LAND ADJACENT TO HMP GARTH AND
HMP WYMOTT, LEYLAND, LANCASHIRE
APPLICATION REF: 21/01028/OUTMAJ

Technical Note

Review of Atkins Additional Evidence on behalf of
Chorley Council

Figure 5.20 Mini-roundabout visibility distance 'D' and stopping sight distance 'F'

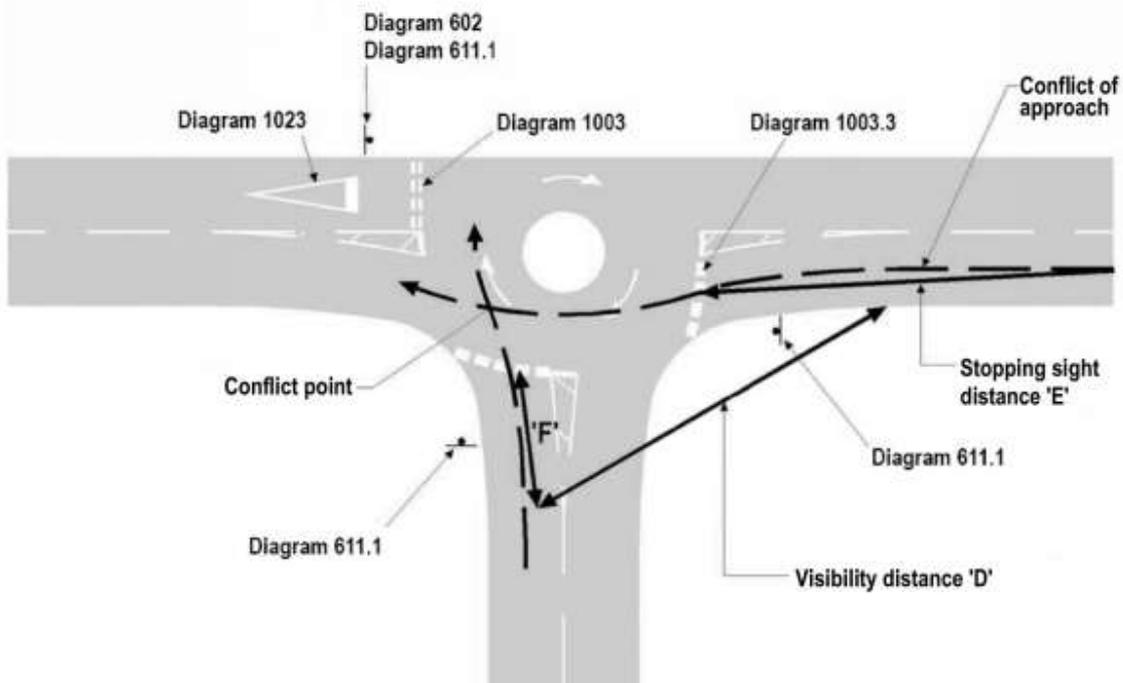
- 5.1.34. Furthermore, the visibility for the proposed mini roundabout is significantly below the standards set out in DMRB CD116 paragraph 5.20. This is recognised in the Atkins report at section 5.6 but the severity of such a breach of standards is not addressed.

5.1.36. It should be noted that Atkins have assumed an 85th percentile speed of 30mph at this junction. There is no evidence to support that the existing 85th percentile speeds on the approaches to the junction are 30mph. A current speed survey would have been able to establish this but does not seem to have been undertaken.

5.1.37. There is also no evidence that a reduction in 85th percentile speed to 25mph would be achievable with the proposals.

5.1.38. As such, the minimum visibility distance 'D' on each approach that should be considered based on the 85th percentile speed of 30mph as indicated by Atkins, is 35m.

Figure 6-1 - Proposed Construction Routes

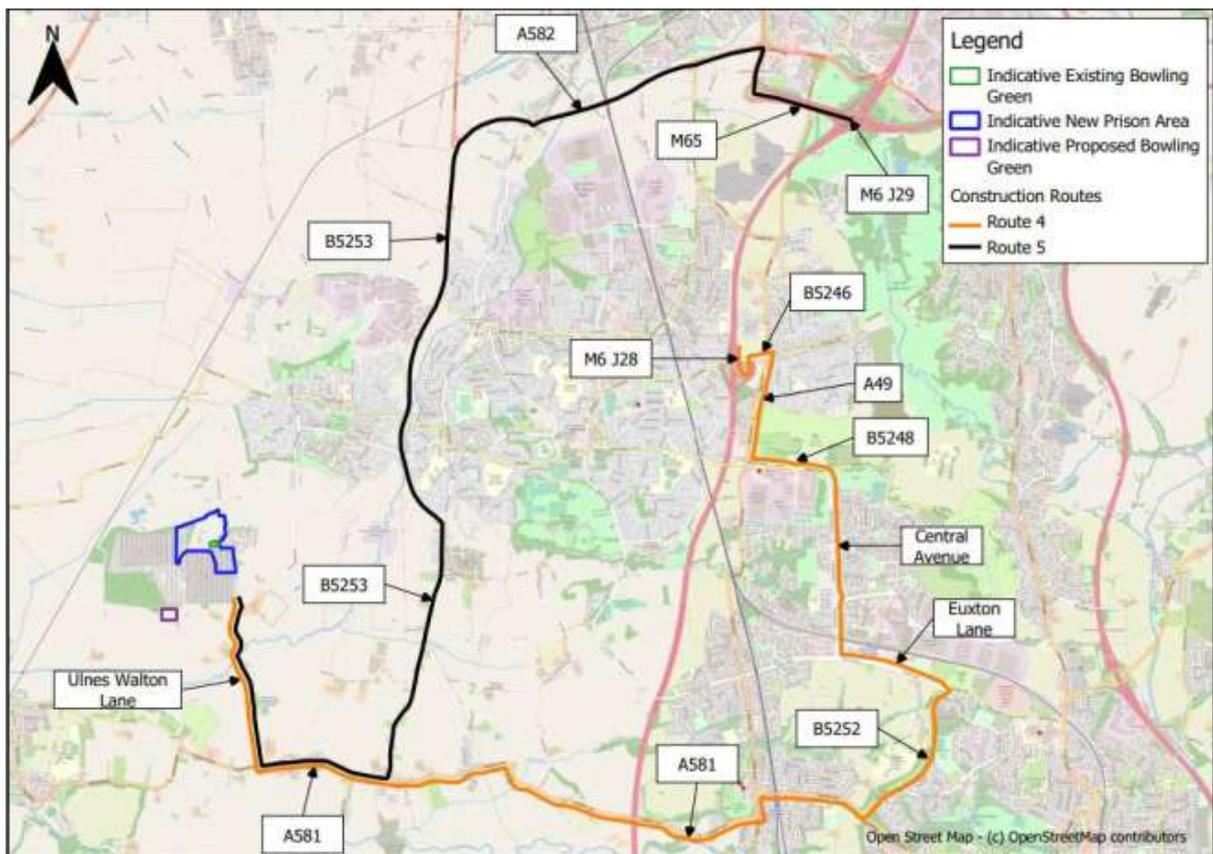
- 6.1.4. The figure clearly illustrates that construction heavy goods vehicles will route south despite the 7.5t weight restriction on Ulnes Walton Lane. This will result in an increase of large vehicles making the left-turn from Ulnes Walton Lane to the A581 east and an increase on the right-turn into Ulnes Walton Lane from the A581 east.
- 6.1.5. As set out in section 5, the vehicle tracking provided by Atkins in Appendix J illustrates that those turns cannot safely be made by large heavy goods vehicles, and the conclusion from Atkins that this will not be made by large vehicles due to a weight limit is simply incorrect

based on their own construction traffic routing and given that vehicles to and from the site are likely to be heavier than this.
